**Date:** Monday 4, Tuesday 5 and Wednesday 6 October 2021  
**Time:** 9.30am  
**Meeting room:** Manukau Room  
**Venue:** Ground Floor, Civic Annex  
31-33 Manukau Station Road, Manukau,

**PRIVATE PLAN CHANGE 61**  
**HEARING REPORT**  
**WAIPUPEKE**  
**LOMAI PROPERTIES LIMITED**

**Figure 26: Coverage map of proposed PC61 open space and DOSP open space network**

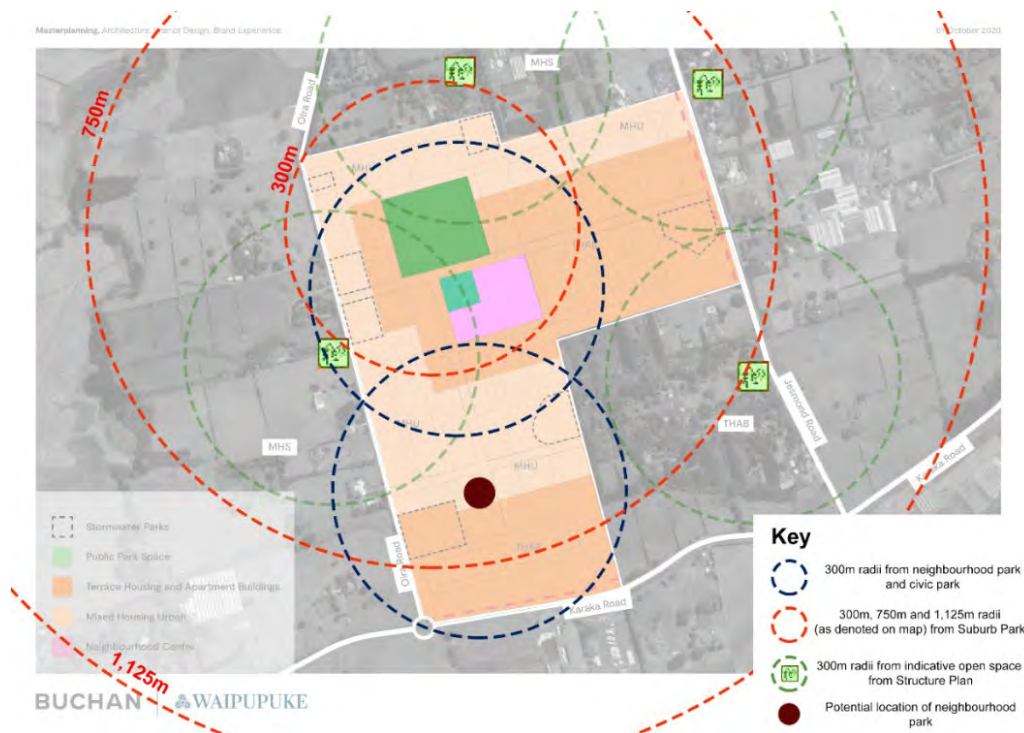
165. As shown **Figure 26** above, there are high levels of overlap between the access circles which highlights an over-supply of parks. Additional provision of Neighbourhood parks provides only marginal benefit that is not expected to meet Council's acquisition or maintenance priorities. Additional areas of open space not expected to form part of council's parks network are not supported.

Figure 32: Walking distances from FTN (rail) and FTN (bus) services

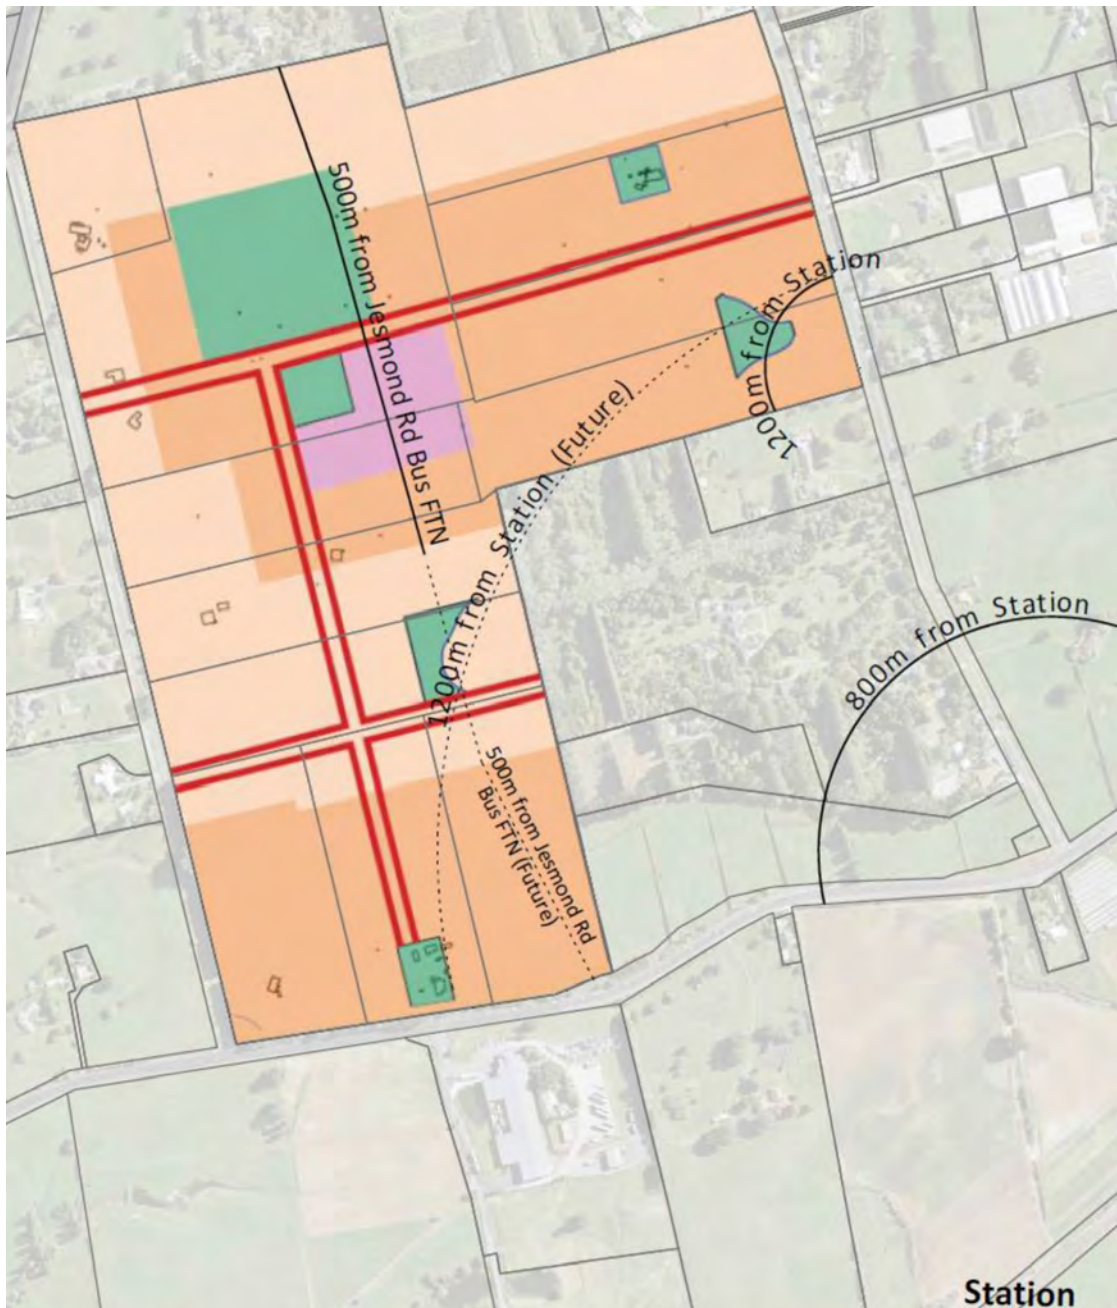
227. For access to the future FTN on Jesmond, **Figure 32** above shows two separate extents of a 500m walking distance from Jesmond Road. The solid line shows the distance assuming the neighbour site to the south-east of PPC61 is not developed. The dotted line shows the distance assuming that the neighbouring site is developed, and urban paths have been formed.

228. For access to the Drury West Station (RTN), **Figure 32** above shows walking distances (800m and 1,200m – solid lines) to the station assuming the neighbouring site to the south-east of PC61 is not developed. The dotted line shows the distance (1,200m) assuming

Figure 35: Road network within PC61

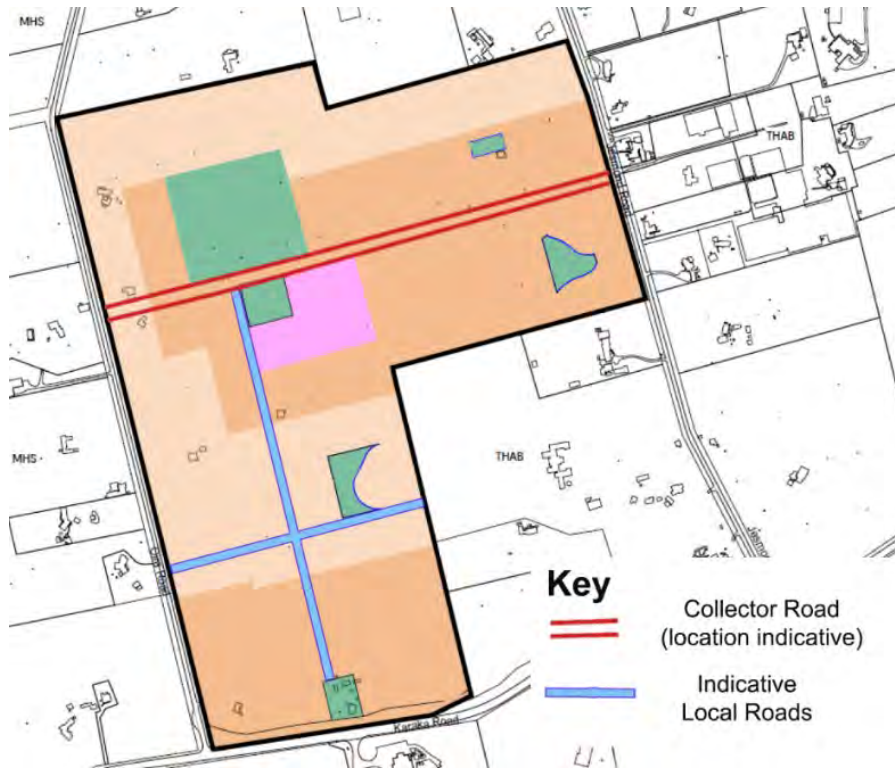
261. Given the uncertainties noted above, I agree with Mr Edwards that some flexibility on the location of the northern east-west collector is required with the exact location of the road to be determined at the resource consenting stage. The key in Precinct Plan 3 should be modified to note that the location of the collector road is 'indicative'.
262. In my view, indicative local roads can be shown on Precinct Plan 3 as they do provide a structuring role within the precinct. The proposed modifications to Precinct Plan 3 are shown in **Figure 35**.

**Figure 39: Recommended modifications to zoning**

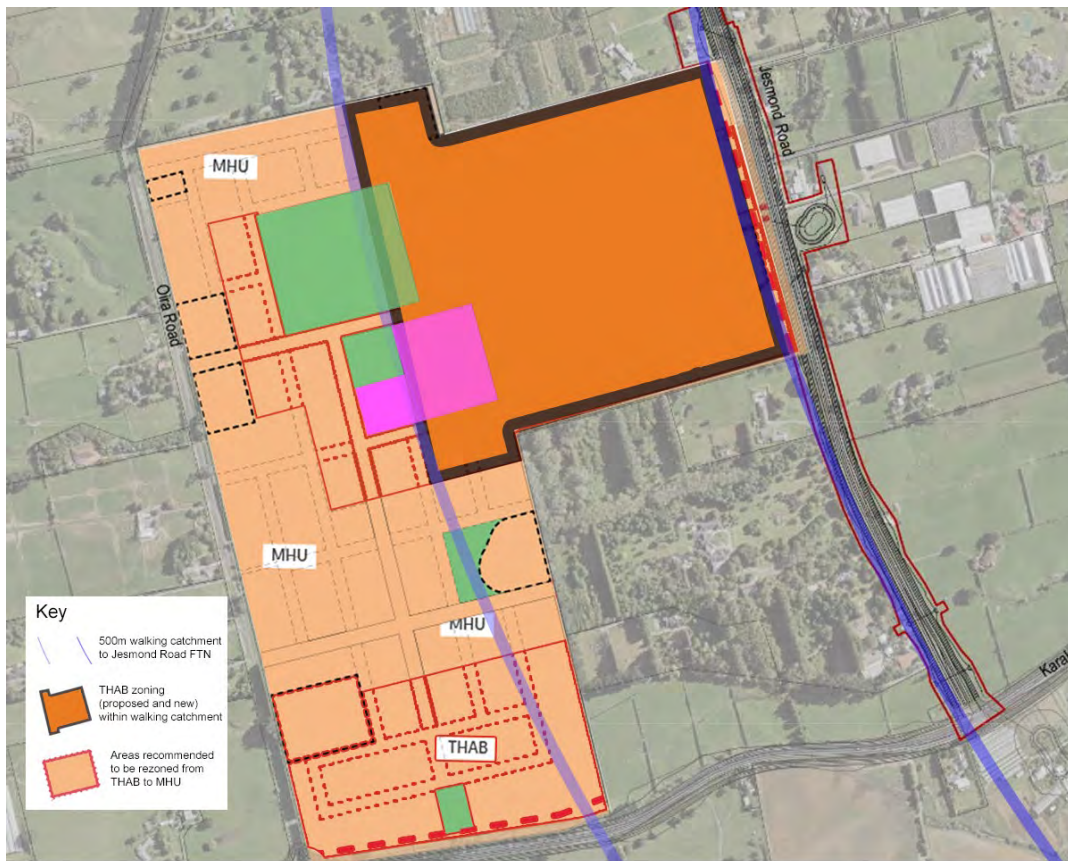
268. I consider that the high intensity THAB zones are best located within a walkable catchment to the FTN bus service on Jesmond Road, in line with Mr Edward’s recommendations. The proposed amendment to the THAB zone is shown in **Figure 39** overpage.

Figure 62: Proposed modifications to precinct plans to include access restrictions

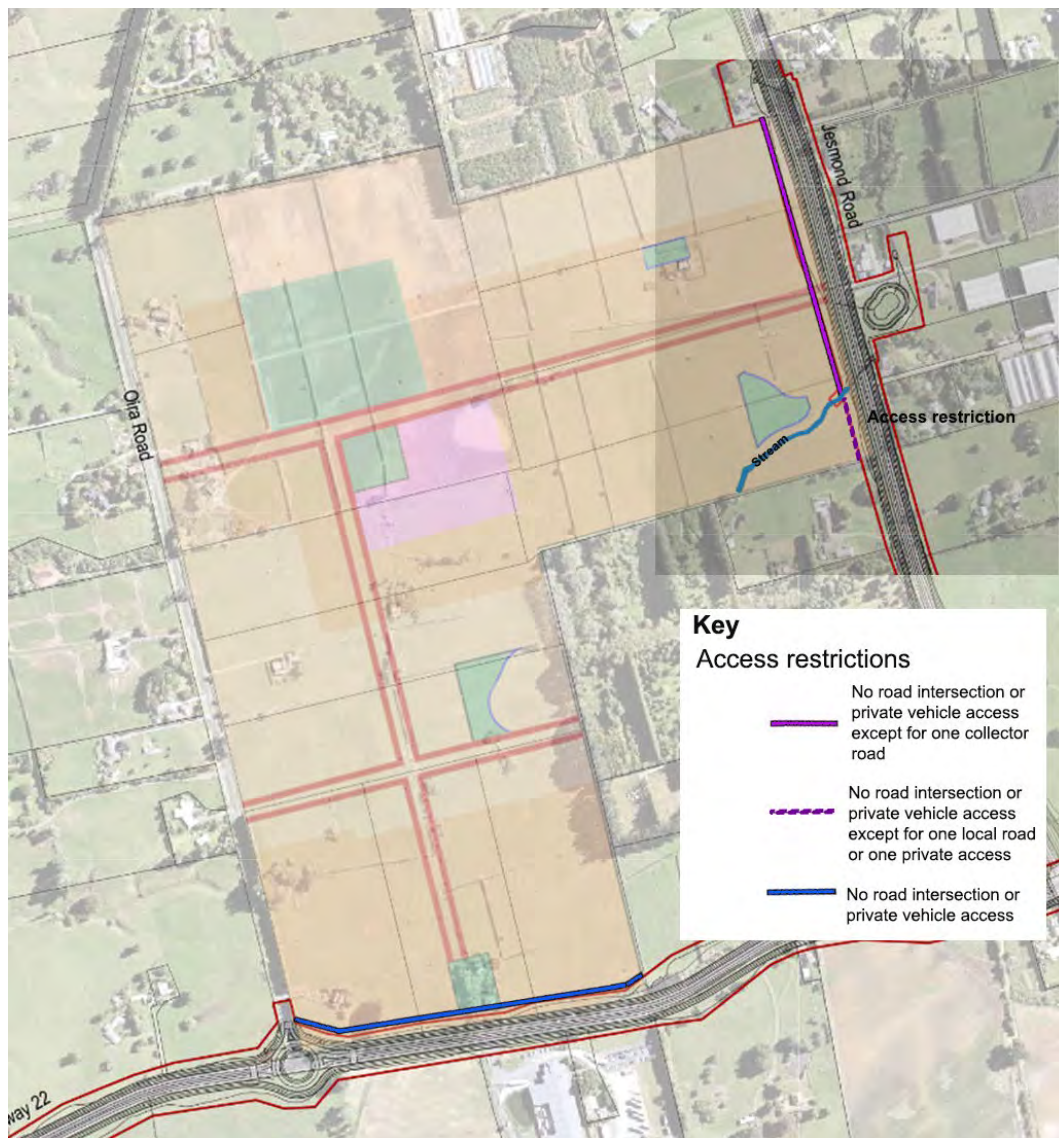
533. AT [22.16] requests that the extent of vehicle access restrictions are shown on the Precinct Plans. This is supported and an amended precinct plan is included in **Figure 62** below.

Figure 64: Comparison of DOSP wastewater servicing plan against that proposed for PC61

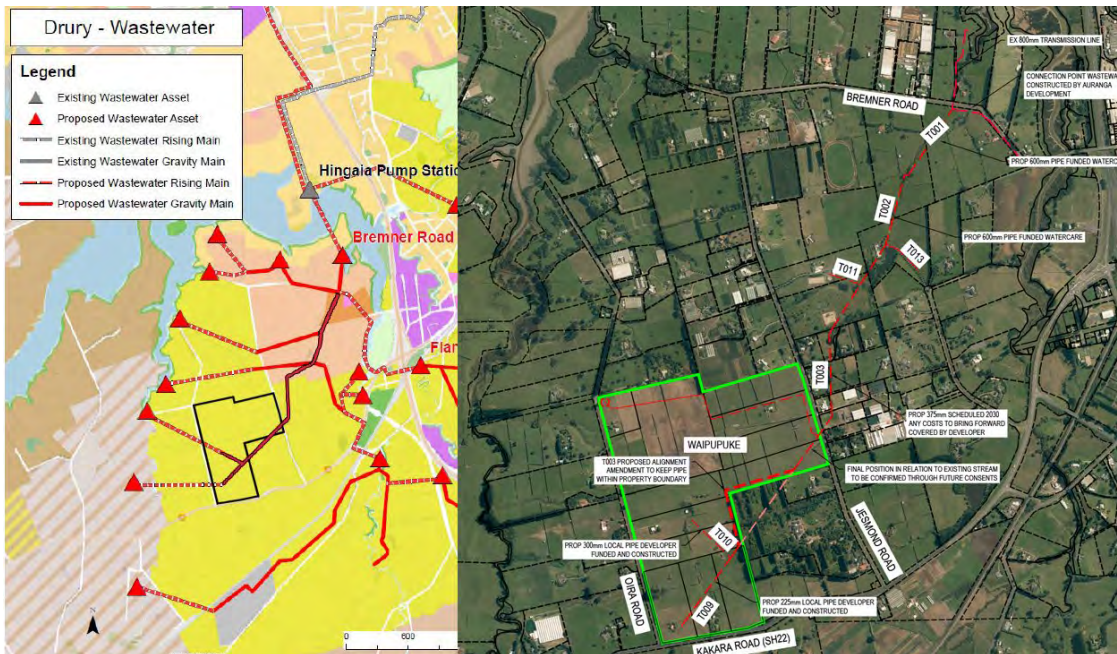
664. As shown on **Figure 64** below, the proposed wastewater alignment to support PPC61 is shown (on the right) next to what was indicated in the DOSP Water and Wastewater Servicing Plan, prepared by Watercare (on the left). The requestor has followed the route proposed by Watercare. Watercare's submission notes that there are still unresolved funding and timing matters relating to infrastructure delivery, but it appears that Watercare is not opposed to the alignment of the proposed wastewater network.
